Servicing / Technical bulletin number: 090

Subject: Change to HALO operating Head torque wrench (Halkey Roberts)

Change to Crewsaver operating Head torque wrench 10439

Standard socket

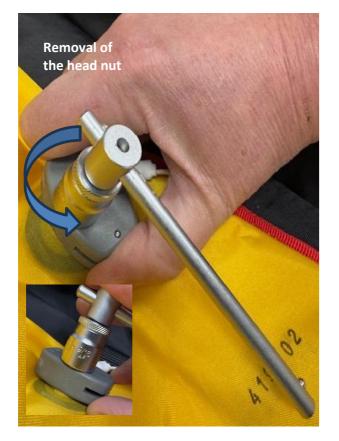
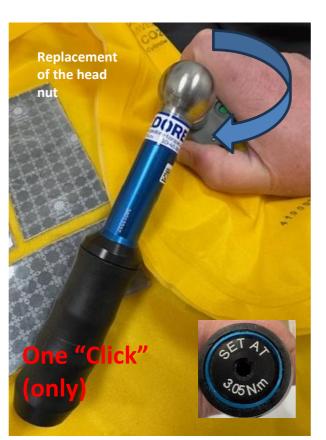
The supplier of the calibrated torque wrench part code 10439 has stopped manufacture to this item.

This has been replaced by a new version of the torque wrench and a T-Bar.

They will be supplied under the same Part code. (10439)

The T-bar replaces the welded ¼ drive point on the head of the old tool, that was used to remove the nut from Halkey Roberts (HR) Heads.

The New version tool is supplied with the Standard 9/16 socket which is required when removing the HR operating Heads

Please ensure the correct approved tools are used for removal and replacement of the operating head.

NOTE. The old version tool is still approved to use and does not need to be changed.
